Road Safety Audit Stage 1

Land South of Salisbury Road

Totton

Report Title Road Safety Audit Stage 1

Title
SIGNAL JUNCTION TRACKING

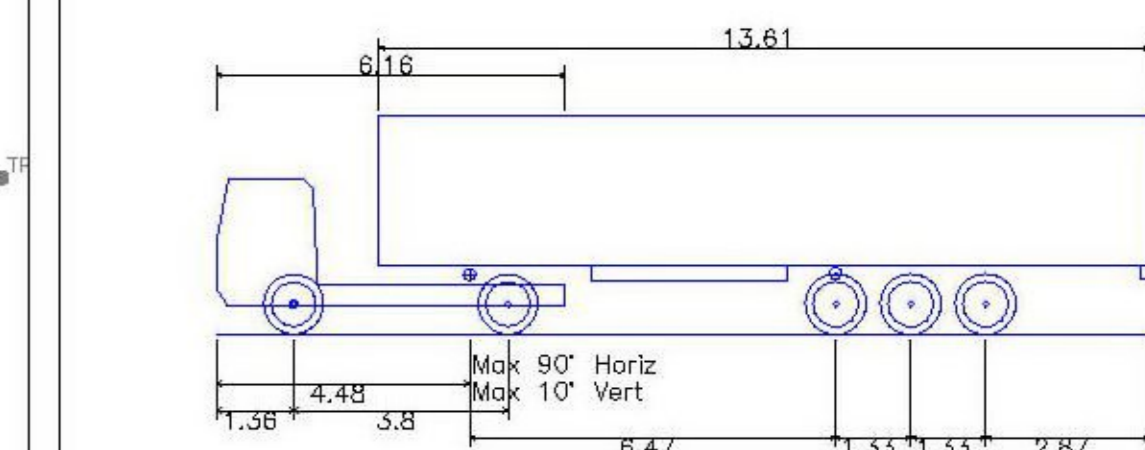
The proposals do not include the introduction of anti-skid surfacing or a surface with a high polished stone value (PSV) on the approaches to the signalised junction. Surfacing with an inadequate PSV could lead to vehicles not being able to stop, leading to possible rear end shunt or fail to stop collisions.

No traffic survey information was provided for assessment, where a national speed limit applies to this section of Salisbury Road. Excessive speeds on the approaches to the junction, particularly outside peak periods, may affect the safe operation of the junction and could lead to vehicles not being able to stop, leading to possible side impact collisions or rear end shunts.

On the Salisbury Road approaches to the proposed signalised junction, existing foliage on Salisbury Road may interfere with the visibility of the signal heads. This may result in overshoots of the signal stop line, with resultant fail to stop collisions, or rear end shunts.

No vehicle maintenance bay has been shown on the plan provided, where a lack of provision may result in operatives parking in unsafe locations, resulting in sideswipe or rear end shunts, or result in conflicts with pedestrians if the vehicles mount the footway.

During the site visit it was noted that there is an existing adverse camber on the southbound approach to Salisbury Road from the A326, where this section of carriageway is proposed to be widened to accommodate two lanes. An adverse camber could lead to possible loss of control collisions, load shifting and vehicle overturning and be particularly problematic for powered two-wheel users.

A storage length of 120m is proposed on the southbound approach to the signalised junction. However, no forward visibility splay has been provided for assessment to the end of the predicted queue. There is concern that the splay could pass over non-highway land, where vegetation or landscaping features in this splay could restrict visibility, where insufficient visibility could lead to rear end shunts.

This section of Salisbury Road has a national speed limit, further there is a vertical crest on the eastbound approach to the junction. A forward visibility splay of 53m to the primary signal is proposed, where on the westbound approach there is corresponding 133m forward visibility splay. There is concern that an insufficient forward visibility splay could lead to rear end shunts or side impact collisions.

This section of Salisbury Road has a national speed limit, further there is a vertical crest on the western arm and a right bend on the northern arm, where a forward visibility of 49m is proposed. There is concern that the signal heads may not be sufficiently visible, where a lack of visibility of signal heads could lead to failure to stop at signals, rear end shunts or side impact collisions.

The staging diagrams for the west and eastbound movements share a combined signal phase. There is concern that traffic will turn in gaps in the opposing flow but if this is not possible then is likely that they will turn in the intergreen period. However, should there be insufficient gaps in traffic flows or an insufficient intergreen period, traffic may turn right in inappropriate traffic gaps. This could lead to side impact collisions or rear end shunts.

A national speed limit currently applies to this section of Salisbury Road, where at this early stage no details have been provided of the type of signal posts to be installed, specifically relating to the passive safety rating and class use for locations. Poor design of posts may increase the injury severity in the event of collision by an errant vehicle.

RSA Problem	RSA Recommendation	Design Organisation response)	Overseeing Organisation response	Agreed RSA action
<p>3.1.1 Location: Approaches to the proposed signalised junction.</p> <p>Summary: Inappropriate surfacing could lead to fail to stop collisions or rear end shunts.</p> <p>The proposals do not include the introduction of anti-skid surfacing or a surface with a high polished stone value (PSV) on the approaches to the signalised junction. Surfacing with an inadequate PSV could lead to vehicles not being able to stop, leading to possible rear end shunt or fail to stop collisions.</p>	<p>It is recommended that antiskid surfacing or surfacing with a high PSV should be used on the approaches to the junction.</p>	<p>Noted – Suitable surfacing would be provided at the junction and will be considered as part of the detailed design stage.</p>

<p>3.1.2 Location: Proposed signalised junction.</p> <p>Summary: Excessive speed on approaches to junction could lead to side impact collisions or rear end shunts.</p> <p>No traffic survey information was provided for assessment, where a national speed limit applies to this section of Salisbury Road. Excessive speeds on the approaches to the junction, particularly outside peak periods, may affect the safe operation of the junction and could lead to vehicles not being able to stop, leading to possible side impact collisions or rear end shunts.</p>	<p>It is recommended that the 85th percentile speeds should be checked to see if speed discrimination equipment is required.</p>	<p>Speed Surveys have been undertaken for the A326 off-slip and the A36 east and westbound arms and confirm the recorded vehicle speeds are considerably less than those posted. This is summarised within the Transport Assessment and visibility splays on the general arrangement drawing reflective of such.</p>

<p>3.1.3 Location: Salisbury Road.</p> <p>Summary: Inappropriate speed limit and increased vehicle movements could lead to side impact collisions or rear end shunts.</p> <p>A national speed limit currently applies to this section of Salisbury Road, where it is likely that the development will see</p>	<p>It is recommended that a lower speed limit should be applied to this section of Salisbury Road.</p>	<p>Through the wider SS1 allocation, consideration is being given to reduce the vehicle speeds along the A36 Salisbury Road, and the actual recorded speeds are considerably less than the posted speeds in any instance.</p> <p>The nature of the area for a large mixed-use development, and with the addition of the Bloor Homes application to the east of the proposed site (including introduction of a new four arm roundabout), the characteristics of the locale will be</p>

<p>3.1.5 Location: Proposed scheme.</p> <p>Summary: Ponding of surface water could lead to loss of control collisions.</p> <p>Carriageway widening is proposed and kerblines are being amended / introduced as part of these proposals, where no details of carriageway drainage have been provided for assessment. Ponding on the carriageway or water moving across the carriageway at junctions or bends could lead to loss of control collisions, particularly in wet / icy conditions.</p>	<p>It is recommended that drainage details should be provided at Stage 2 Road Safety Audit.</p>	<p>Noted – details will be provided at the detailed design stage for consideration through the Stage 2 safety audit.</p>		
<p>3.1.6 Location: Salisbury Road approaches to proposed signalised junction.</p> <p>Summary: Obscured signal heads could lead to fail to stop collisions or rear end shunts.</p> <p>On the Salisbury Road approaches to the proposed signalised junction, existing foliage on Salisbury Road may interfere with the visibility</p>	<p>It is recommended that the foliage should be trimmed and that a regular maintenance programme to trim the foliage should be employed.</p>	<p>Noted – Where vegetation is provided within the visibility splays, this will be maintained to below 600mm or canopies above 2m.</p>

<p>of the signal heads. This may result in overshoots of the signal stop line, with resultant fail to stop collisions, or rear end shunts.</p>				
<p>3.1.7 Location: Proposed signalised junction. Summary: Lack of maintenance provision could lead to side swipe collisions, rear end shunt or vehicle to pedestrian collisions. No vehicle maintenance bay has been shown on the plan provided, where a lack of provision may result in operatives parking in unsafe locations, resulting in sideswipe or rear end shunts, or result in conflicts with pedestrians if the vehicles mount the footway.</p>	<p>It is recommended that a vehicle maintenance bay should be provided at a location, which does not interfere with the visibility splays.</p>	<p>Noted – An existing layby is located in the vicinity of the junction which could be utilised by maintenance vehicles. Alternatively if not considered appropriate by HCC, a bay could be provided on the internal access road to the site.</p>

<p>No construction details for the proposed footway / cycleway link were provided. Surfacing with an insufficient Polished Stone Value (PSV) could lead to overshoot at junctions or cyclist loss of control collisions in the event of sudden braking manoeuvres.</p>				
<p>3.2.1 Location: Southbound approach to proposed signalised junction. Summary: Adverse camber could lead to loss of control collisions, load shifting and vehicle overturning and be particularly problematic for powered two-wheel users.</p> <p>During the site visit it was noted that there is an existing adverse camber on the southbound approach to Salisbury Road from the A326, where this section of carriageway is proposed to be widened to accommodate two lanes. An adverse camber could lead to possible loss of control collisions, load shifting and vehicle overturning and be</p>	<p>It is recommended that the carriageway should be reprofiled to remove the adverse camber.</p>	<p>The existing off-slip is already a two-lane approach at the junction with Salisbury Road. The proposed improvements will create a larger radius and taper to help facilitate the movement of larger vehicles in this location. Level details will be considered as part of any detailed design / Stage 2 Road Safety Audit.</p>

<p>particularly problematic for powered two-wheel users.</p>				
<p>3.2.2 Location: Southbound approach to proposed signalised junction. Summary: Lack of forward visibility could lead to rear end shunts. A storage length of 120m is proposed on the southbound approach to the signalised junction. However, no forward visibility splay has been provided for assessment to the end of the predicted queue. There is concern that the splay could pass over non-highway land, where vegetation or landscaping features in this splay could restrict visibility, where insufficient visibility could lead to rear end shunts.</p>	<p>It is recommended that the forwards visibility splay should be supplied for assessment and that the splay should be within the adoptable highway, or that a suitable covenant should be arranged to ensure that the splay is not affected by planting or landscaping features.</p>	<p>Advisory signage of a change in layout would be provided to encourage vehicles to slow as they come off the carriageway. A forward visibility splay would be prepared at the detailed design stage once the initial junction design and associated modelling have been reviewed by the local authority.</p>

<p>3.2.3 Location: Eastbound approach to proposed signalised junction. Summary: Insufficient forward visibility could lead to rear end shunts or side impact collisions.</p>	<p>It is recommended that forward visibility to the primary signal should be commensurate with expected 85th percentile speeds.</p>	<p>The visibility splays have been prepared to accord with the recorded vehicle speeds from the ATC surveys undertaken in August 2023. The results of the ATC surveys identified vehicle speeds of 31.8mph eastbound, 48.1mph westbound and 31.5mph southbound on the A326 off-slip.</p>

<p>to stop at signals, rear end shunts or side impact collisions.</p>				
<p>3.3.2 Location: Proposed signalised junction, south and eastbound movements. Summary: Insufficient opportunity for right turn movements could lead to side impact collisions or rear end shunt collisions.</p> <p>The staging diagrams for the west and eastbound movements share a combined signal phase. There is concern that traffic will turn in gaps in the opposing flow but if this is not possible then is likely that they will turn in the intergreen period. However, should there be insufficient gaps in traffic flows or an insufficient intergreen period, traffic may turn right in inappropriate traffic gaps. This could lead to side impact collisions or rear end shunts.</p>	<p>It is recommended that separate phases for west and eastbound movements should be introduced, though it is recognised that this will impact upon capacity.</p>	<p>Noted and agreed – the staging diagram also shows that whilst in Stage 1 both the west and eastbound movements can go at the same time, there is then a stage whereby the westbound movements stop to enable the eastbound movements (and specifically the right turn movement into the proposed site) to continue (Stage 2). Stage 3 then enables the right turn vehicles from the A36 eastern arm to go with the left turners from the A326.</p>

<p>3.5.1 Location: Proposed signalised junction.</p>	<p>It is recommended that posts and columns are provided that are passively safe with the</p>	<p>Noted – the type of signal posts and signage etc will be provided and considered through the detailed design stage.</p>
